SUBJECT: STORM WINDOW MOUNTING HARDWARE AND TORQUE VALUE

**MODELS/ SN
AFFECTED:** M20V ACCLAIM ULTRA 33-0002, 33-0003

INTRODUCTION: Mooney International Corporation has determined the necessity of a tamper-resistant fastener, for the storm window installation. This service instruction provides the procedure for adding fasteners to the Mooney aircraft listed above, with existing storm window installations.

Figure SB M20-126-1 - STORM WINDOW MOUNTING HARDWARE AND TORQUE

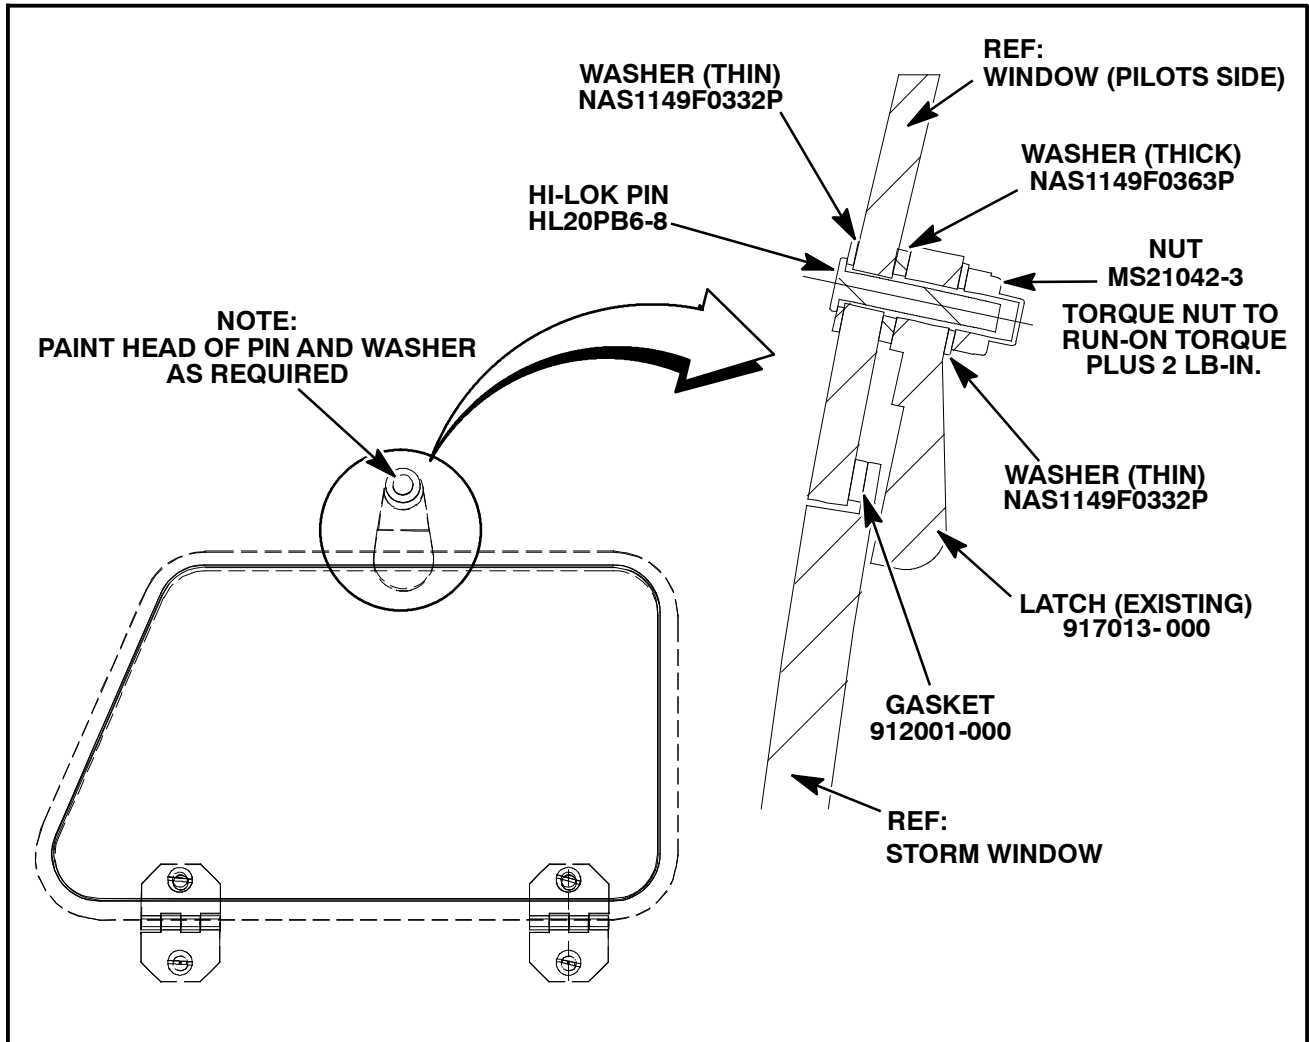
- 1.1. Remove AN526-1032R12 screw, AN960-10 washer and 22K2-02 nut from the storm window latch assembly.
- 1.2. Install (1) Hi-Lok pin (HL20PB6-8 - Painted), (1) Washer (NAS1149F0332P) thru window and from inside aircraft, add (1) Washer (NAS1149F0363P), existing latch, (1) Washer (NAS1149F0332P) and (1) Nut (MS21042-3) (refer to Figure SB M20-126-1).
- 1.3. Torque nut to run-on torque + 2 LB-IN (refer to Figure SB M20-126-1)

Carefully Torque Nut to Run-On Torque + 2 LB-IN. Do not use isopropyl alcohol to clean plexiglass surfaces or attaching hardware. Clean per FAA AC 43.13-1B, paragraph 3-25.
